GLENELLA

Description: Glenella Quarry Pty Ltd DA 73/2007 Condition Modification – Mod 1 – PAN- 205523

Notice of Determination of Development Application
Issued Under Section 81 (1)
Environmental Planning and Assessment Act, 1979

Development Application: 73/2007

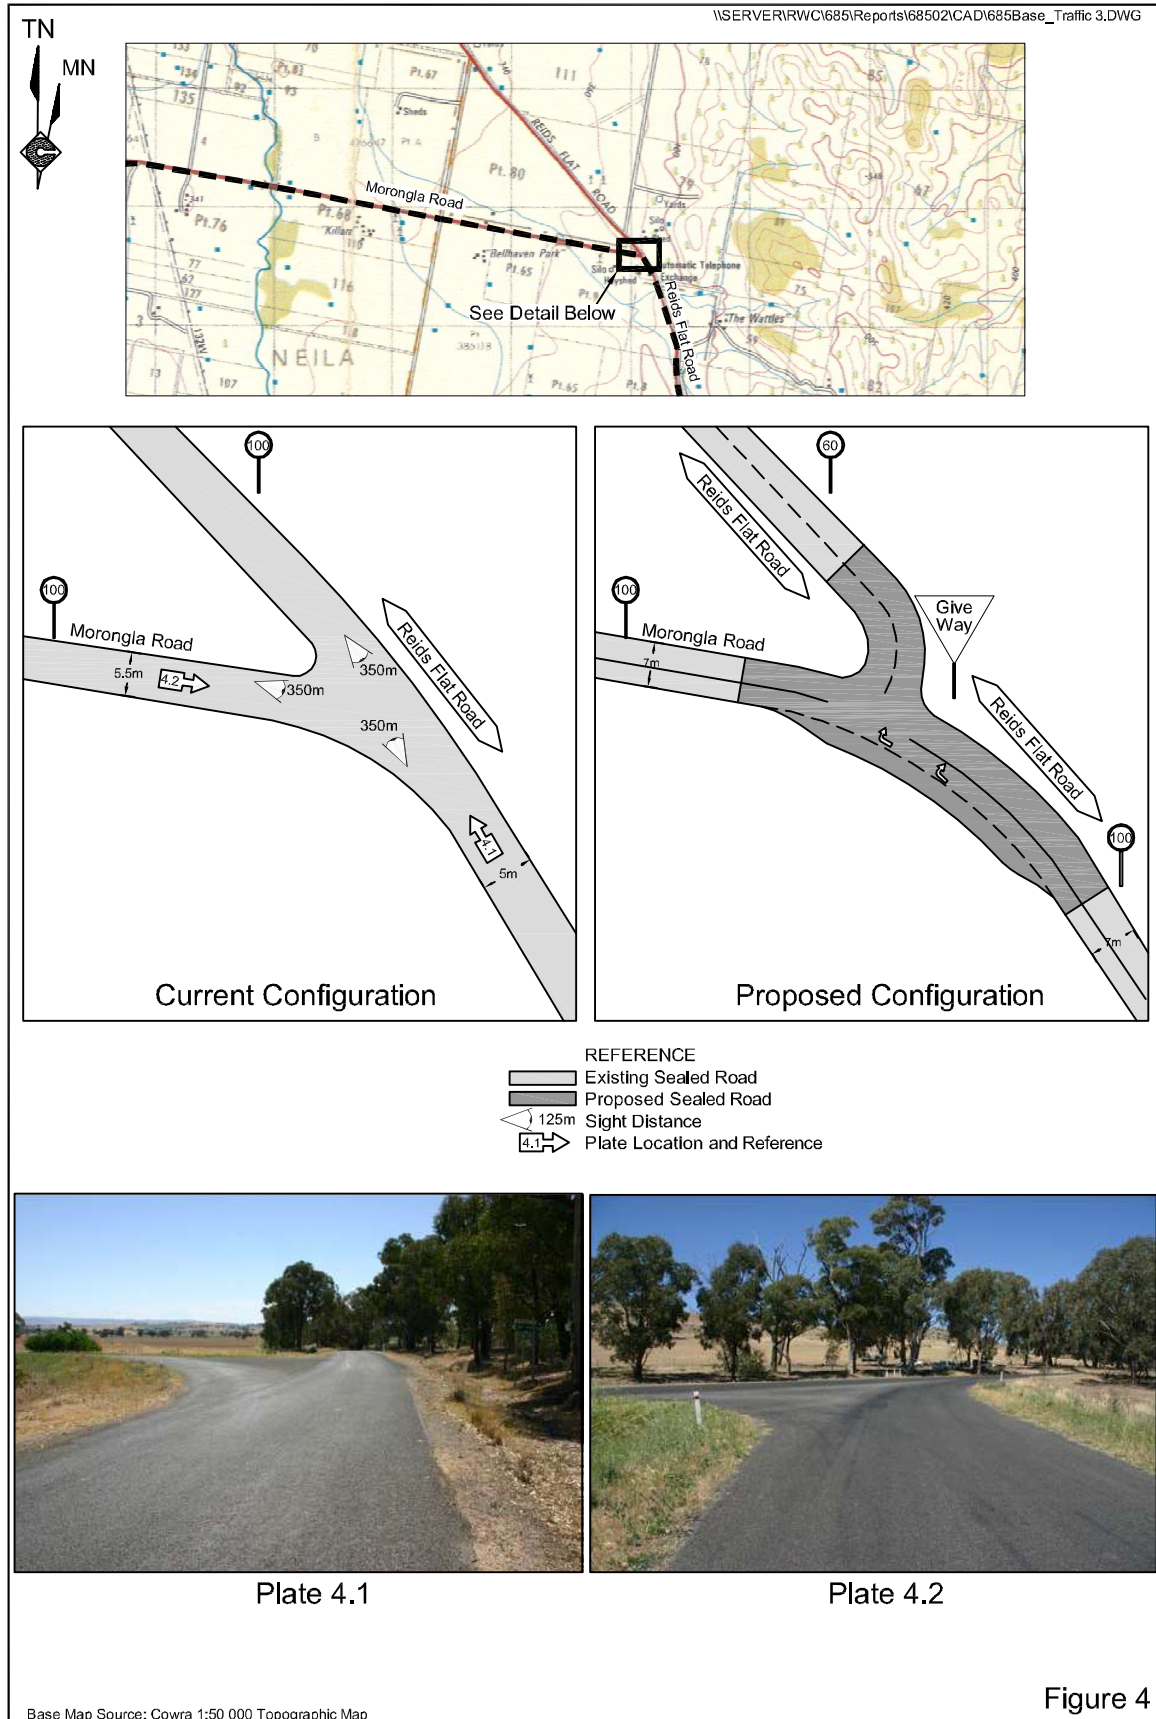
For the Morongla Road / Reids Flat Road intersection; that condition 14 be amended to reflect the recommendations of Section 6.1, Improvement 1 of Appendix 5 'Traffic Impact Assessment' of the 'Glenella Quarry Production Increase Environmental Impact Statement (April 2007). Draft condition wording:

'The intersection of Reids Flat and Morongla Roads shall be designed and constructed to maintain the priority of through-traffic along Reids Flat Road and not Morongla Road; not priority of through traffic along Reids Flat Road. In this regard the final design of the intersection shall incorporate the following:

- *No speed reduction from existing speed zone.*
- *The northern section of Reids Flat Road to form the terminating leg of the intersection.*
- *Regulatory signposting to define road priority and to accord with sight distance provisions.*
- *Provision of line marking and guideposts on the approaches to the intersection for a minimum of 250 metres on each road approach or to start at a point where Approach Sight Distance to the line marking can be achieved generally in accordance with AS 1742.*
- *Sealed pavement widths at the intersection to accommodate the swept paths of heavy vehicles.*

The final intersection design is to accommodate the expected vehicle types and traffic volumes generated by the development and to comply with the RTA Road Design Guide. The final intersection design and construction plans are to be submitted to Council for approval prior to works commencing. Intersection upgrading is to be completed prior to production at the Glenella Quarry increasing beyond the current operating capacity of five truck loads per day, averaged over a weekly period. In this regard, the Applicant is to maintain a logbook detailing the number of truck loads leaving the property each day and Council is to be advised when the five loads per day limit is reached. All costs associated with the provision of new and upgraded roads/intersections shall be at full cost to the Applicant and no cost to either Cowra Shire Council or Transport for NSW.'
